HIGHLAND COUNCIL

Committee: North Planning Applications Committee
Date: 17th September 2024
Report Title: 23/02702/MSC: Compass Building And Construction Services Ltd
Land 255M East Of Culcairn Farmhouse, Station Road, Evanton
Report By: Area Planning Manager - North

Description: MSC application for phase 1 private housing to satisfy matters specified in conditions 1, 2 and 4-25
Ward: 06 – Cromarty Firth
Development category: Major Housing Development
Reason referred to Committee: Manager's Discretion

Drawing No. 3789:115		Revision H
--------------------------------	--	----------------------

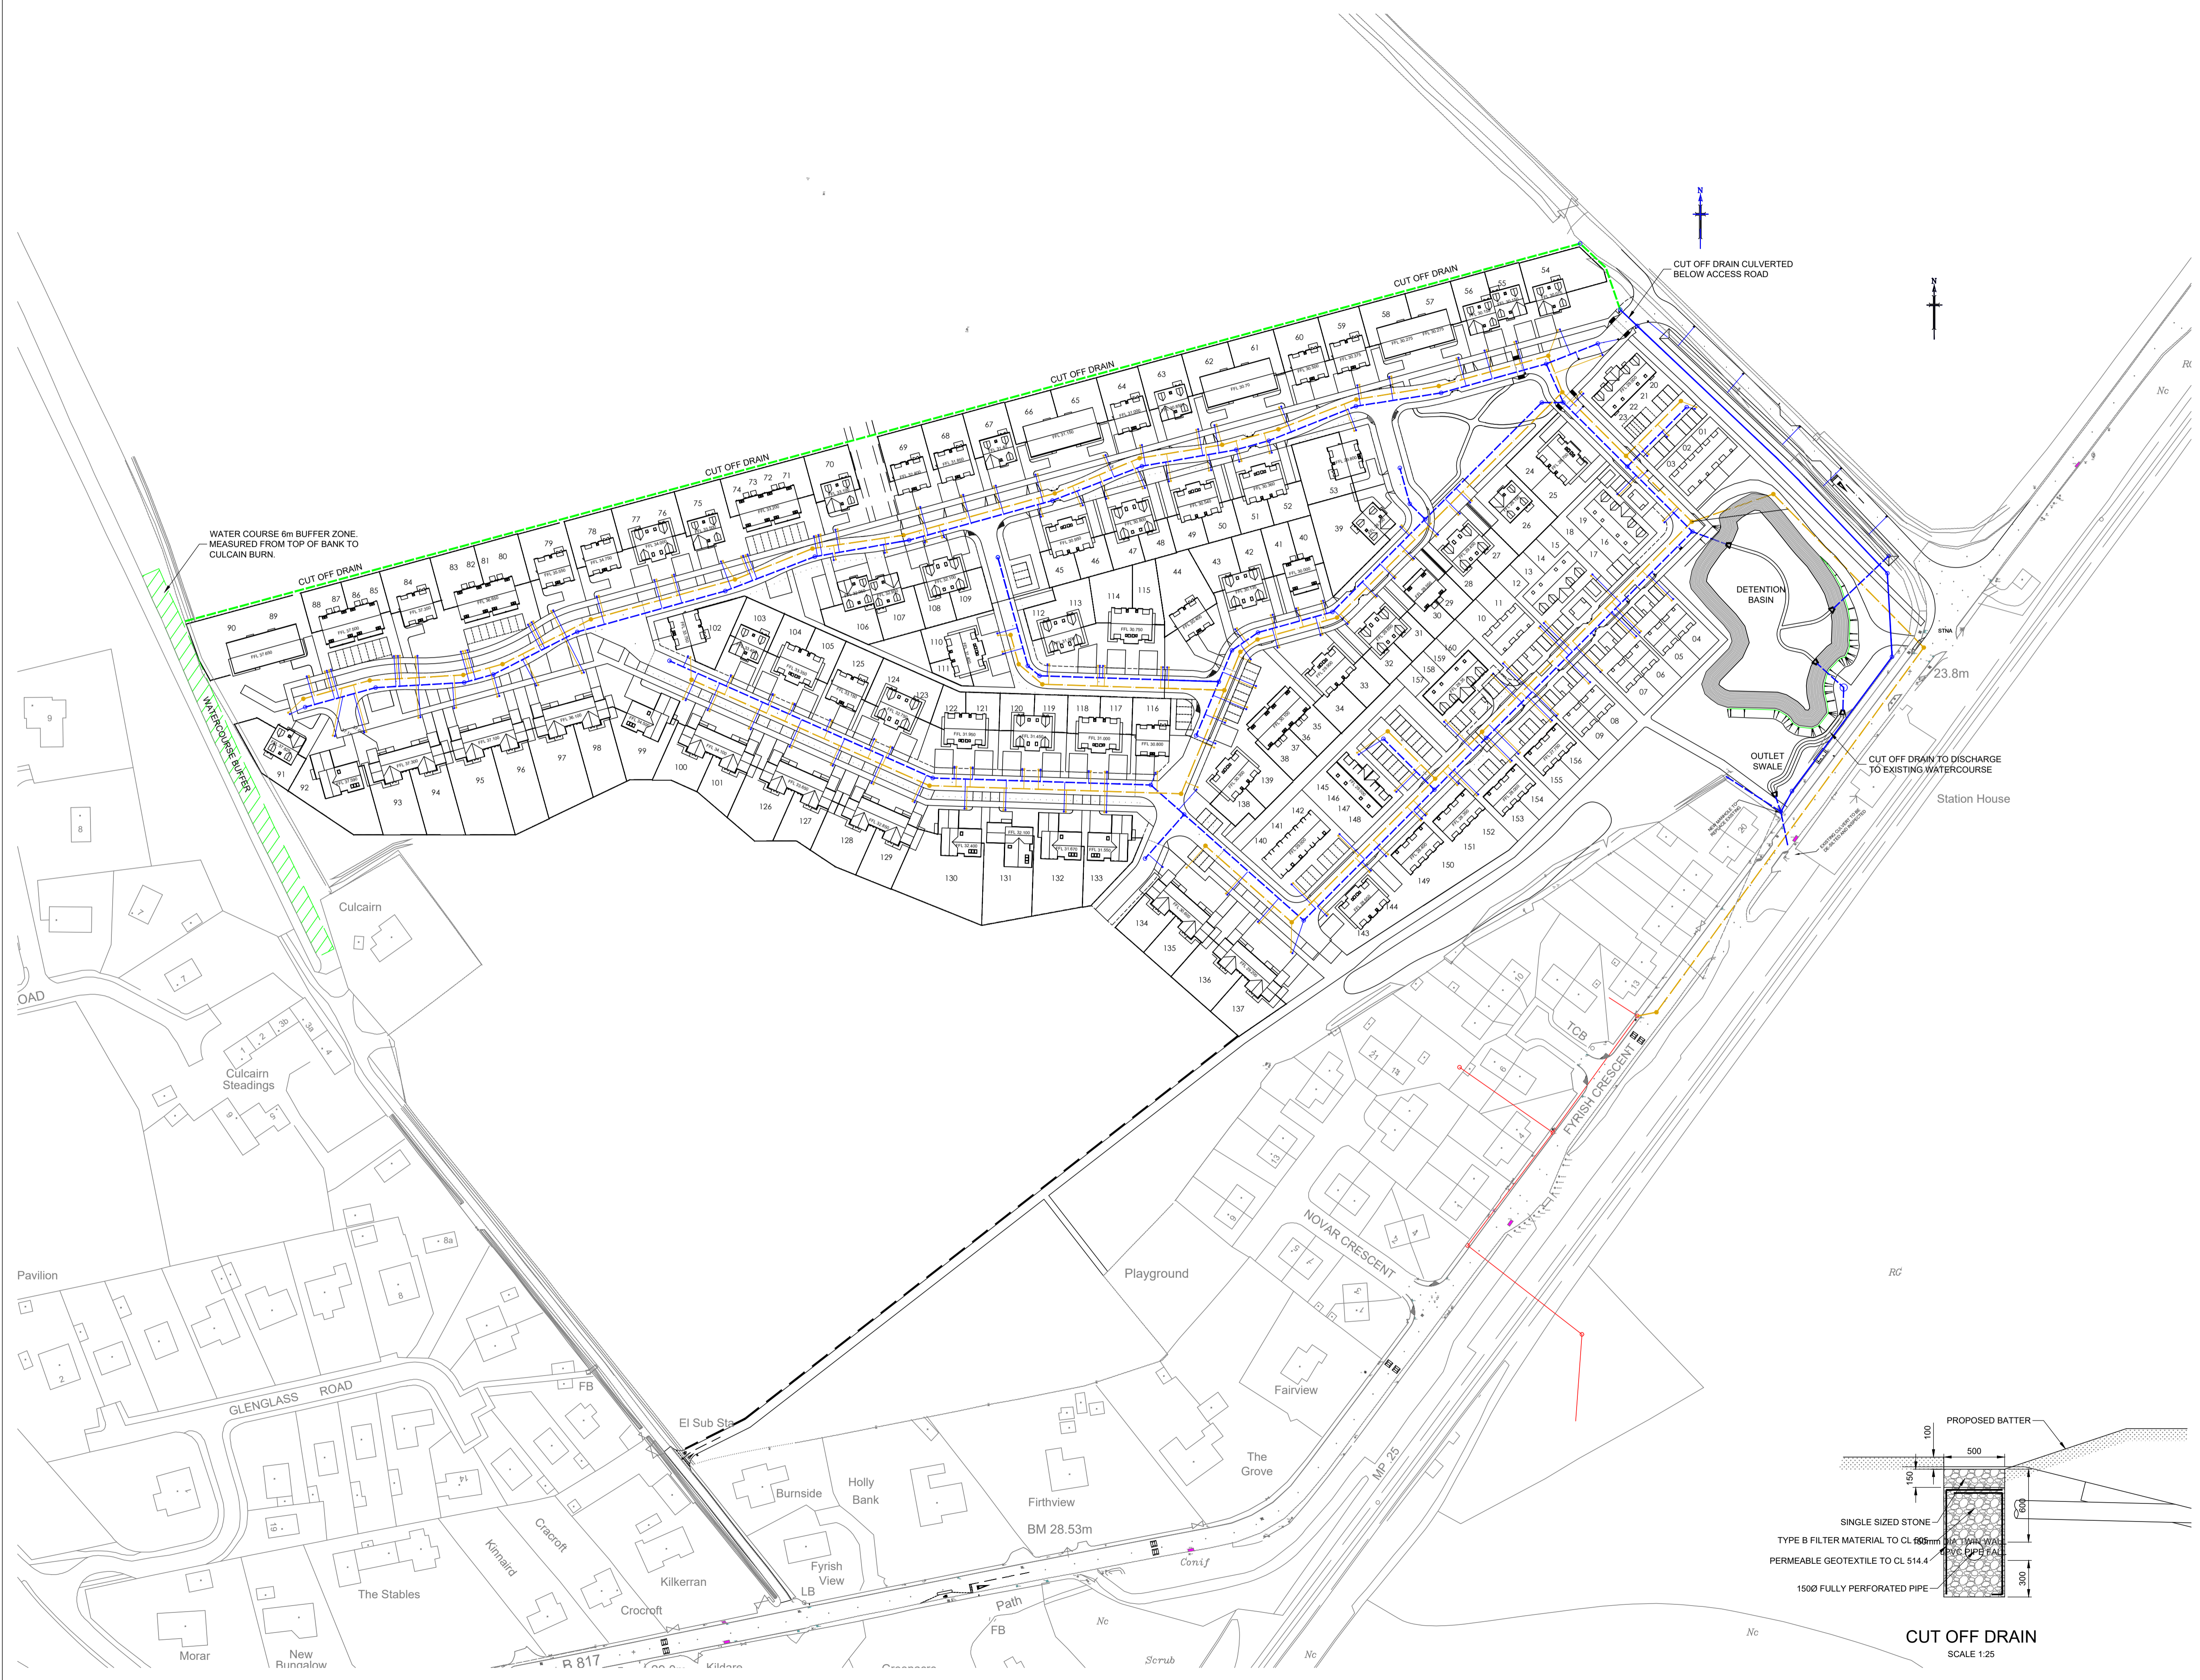
- 8.20 A single large suds basin is proposed discharging into an existing small watercourse which is culverted below Fyrish Crescent. The applicant carried out CCTV surveys of the drainage outfall. The culvert appears to be a masonry arch beneath the footway of Fyrish Crescent but then changes to a twin pipe beneath the carriageway. However, the survey could not be completed as the culvert was obstructed with silt. Drawing 3789: 115 Rev H confirms that a new manhole will be constructed where the suds basin discharges to the existing culvert and that it will be de-silted and inspected. The condition of the culvert will require to be confirmed and any remedial works identified and agreed as part of the Roads Authority consents required to construct the road and to connect into the existing road culvert.

- 8.21 Concerns were raised about the lack of space between the basin embankment, the swale and the footway of Fyrish Crescent. The applicant has submitted a proposed contour drawings and cross-sections through the basin, these show the basin and treatment swale just fit into the site. Transport Planning questioned the specifications of the swale and its ability to withstand the exceedance flows and events. In addition, the sections on the additional drawings provided confirm that the embankment for the suds basin will impound the water above ground level and will require detailed structural design to allow for this. Scottish Water will undertake the detailed technical review of this design which will be confirmed prior to issue of the Roads Authority consents required. Based on the information provided condition 4 has been satisfied. Transport Planning have also confirmed that the surface water drainage layout satisfies the pre-start requirements of condition 4 for phases 1A and 1P.

Drawing No.	Revision
3789:190	B

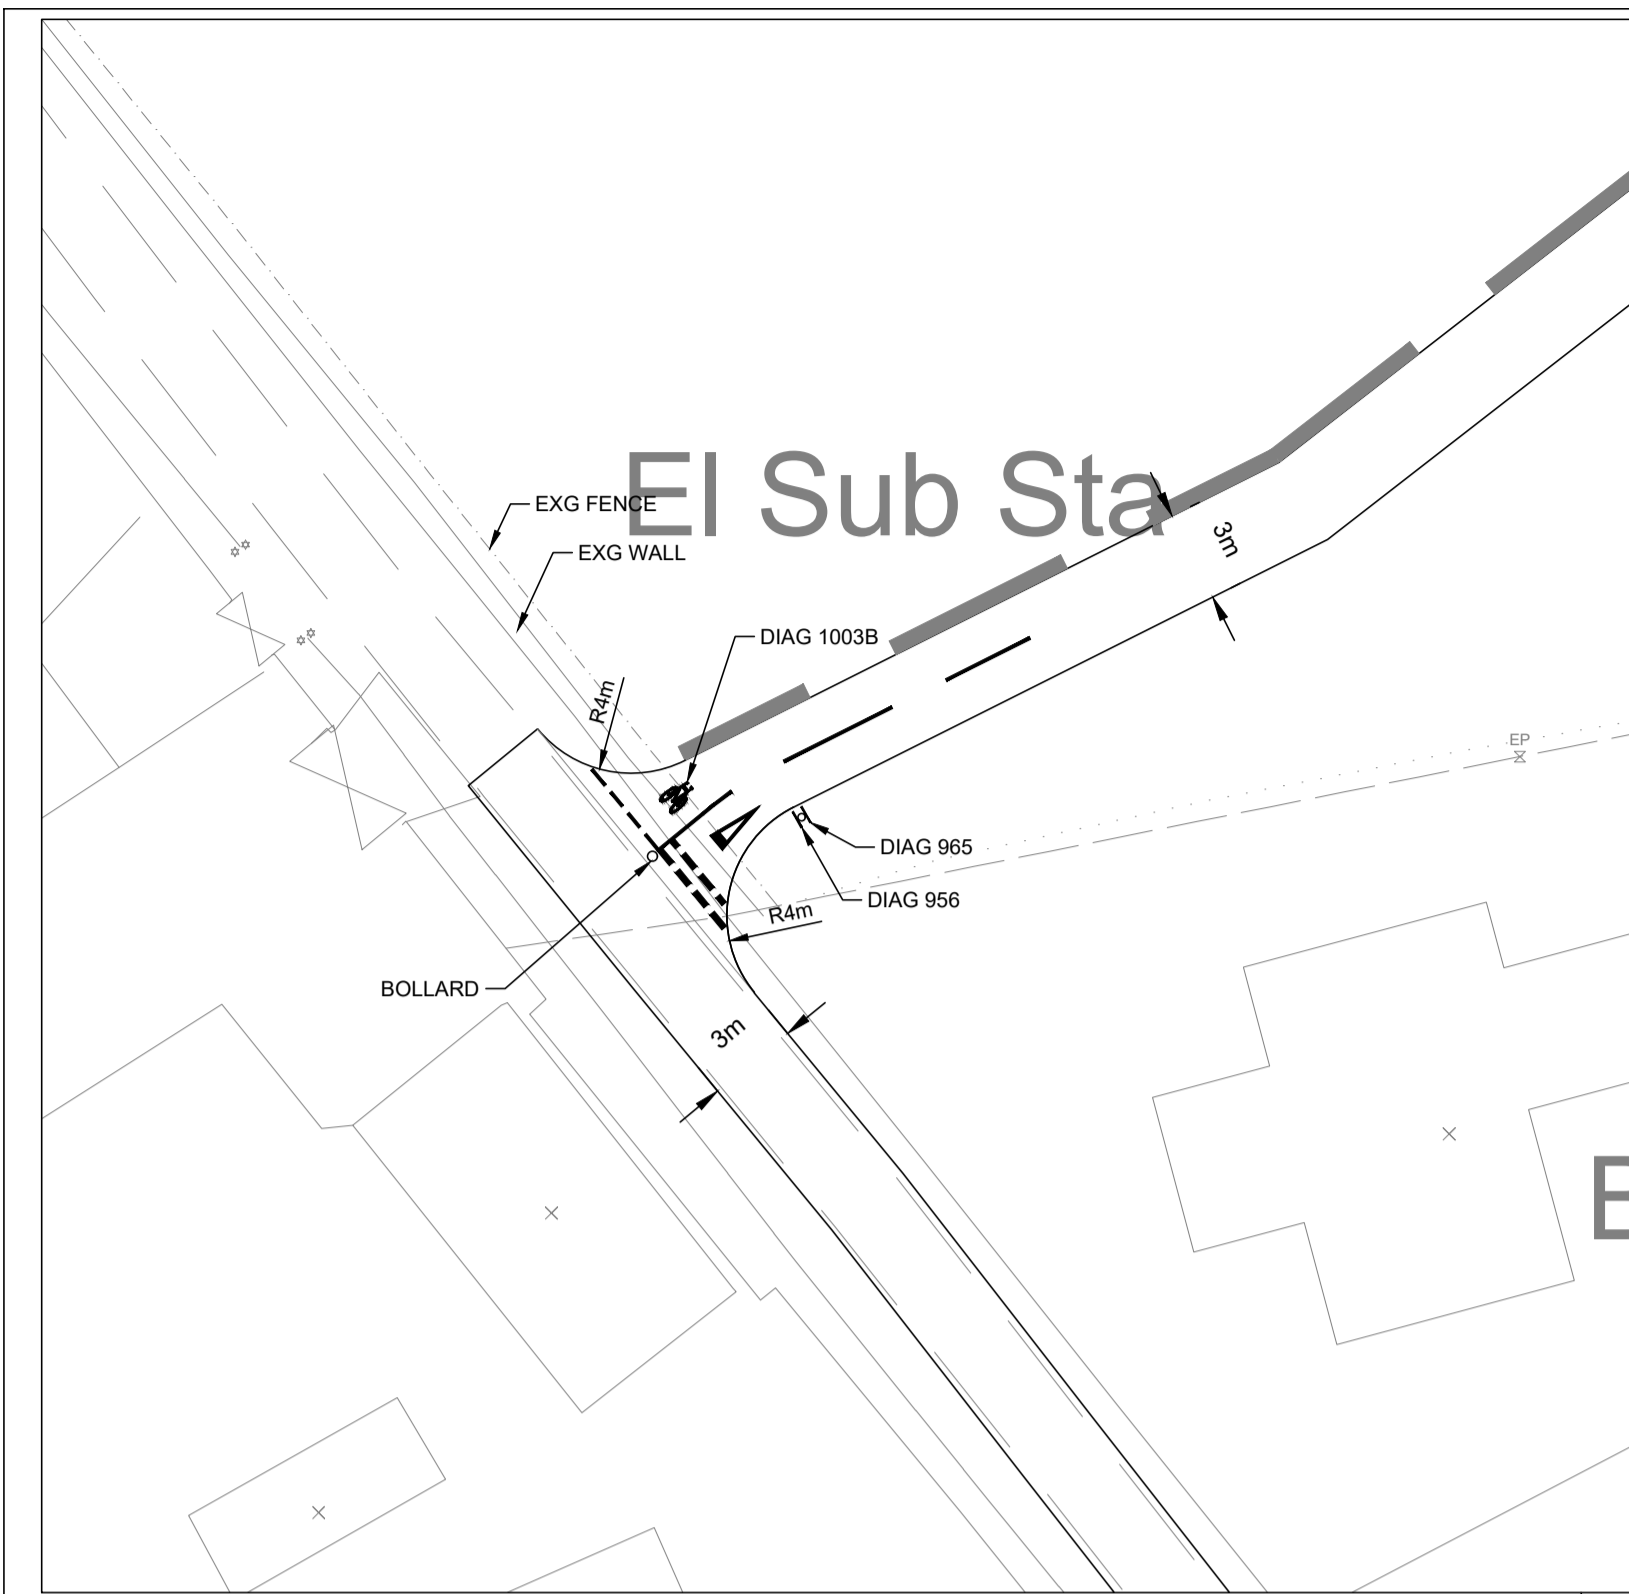
- 8.38 Drawing 3789:190 Rev C shows a 3 m wide shared path over a suitable route. The drawing shows the route to be surfaced and lit. The entire length shall be to adoptable standards. The short section of the lane must be upgraded with surfacing suitable for the motor vehicle access required. The remote section from the lane to the site does not need to support motor vehicles. A link is shown to the existing Council owned playground adjacent to Novar Crescent. This route will form part of the Road

Construction Consent (RCC) application to the Council. It is required to be constructed prior to the occupation of the 40th unit. Detail specifications will be agreed as part of the RCC process. Transport Planning are content that the condition is satisfied and any further information will be secured via the RCC process.
